DRAWING NO. D212-664-141	TITLE XTUBE ASSY (205/212/412 HI FWD)	REV. D	DART AEROSPACE LTD ENGINEERING ORDER		D.E.O. NO. D212-664-141-D-1	SHEET NO. SHEET 1 OF 2	SCALE NTS
DRAWN	CHECKED	MFG. APPR.	APPROVED	DE APPR.			
DATE 11.04.07	DATE 11.04.11	DATE 11.04.12	DATE 11/04/12	DATE 11.04.12

ADD AN INSPECTION WINDOW TO UNDERSIDE OF CROSSTUBE.

DRAWING NO. D212-664-141	TITLE CROSSTUBE ASS'Y (205 HI FWD)	REV. D	DART AEROSPACE LTD ENGINEERING ORDER	D.E.O. NO. D212-664-141-D-2	SHEET NO. SHEET 1 OF 1	SCALE NTS
DRAWN <i>UP</i>	CHECKED <i>ADS</i>	MFG. APPR. <i>DS</i>	APPROVED <i>MP</i>	DE APPR. <i>MP</i>		
DATE 11.07.15	DATE 11.07.20	DATE 11.07.21	DATE 11/07/21	DATE 11.07.21

REPLACE MAGNOBOND WITH PROSEAL.

D212-664-141/-141B
ASSEMBLY DETAIL

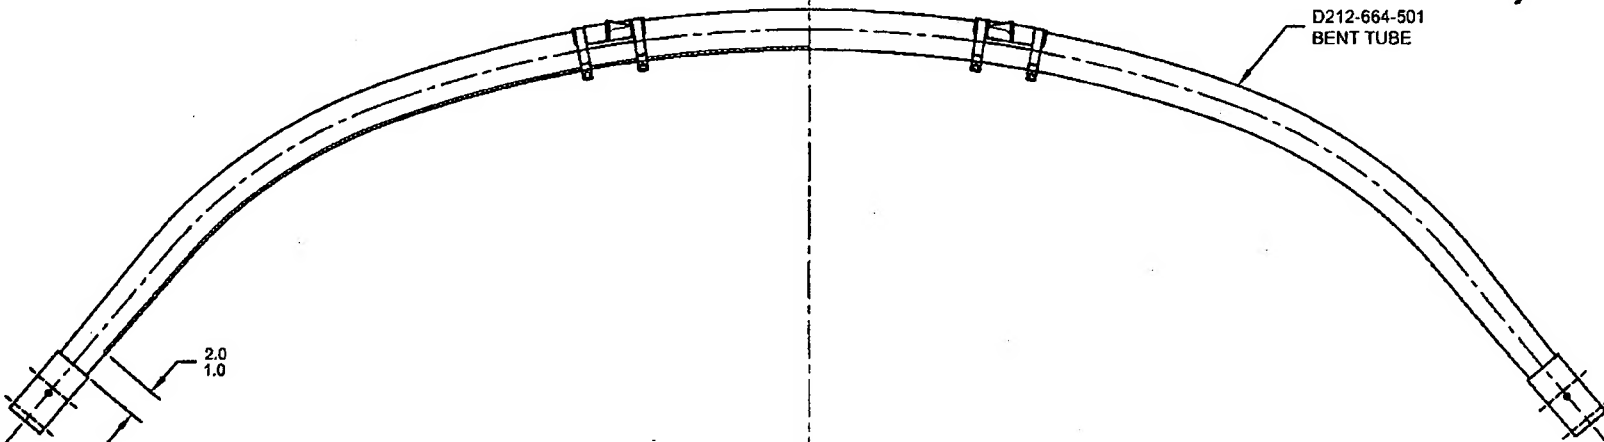
NOTES 2 OF SHEET 1 IS AMENDED AS FOLLOWS:

MASK AREA PRIOR TO PAINTING,
REMOVE MASKING AFTER PAINT
AND APPLY CLEAR COAT

- 2) FINISH: CHEMICAL CONVERSION COAT PER DART QSI 005 4.1
PRIME INSIDE AND OUTSIDE PER DART QSI 005 4.2
MASK UNDERSIDE OF CROSSTUBE AS SHOWN (HATCHED AREA) AND
PAINT OUTSIDE PER DART QSI 005 4.2
REMOVE MASKING AND APPLY CLEAR COAT
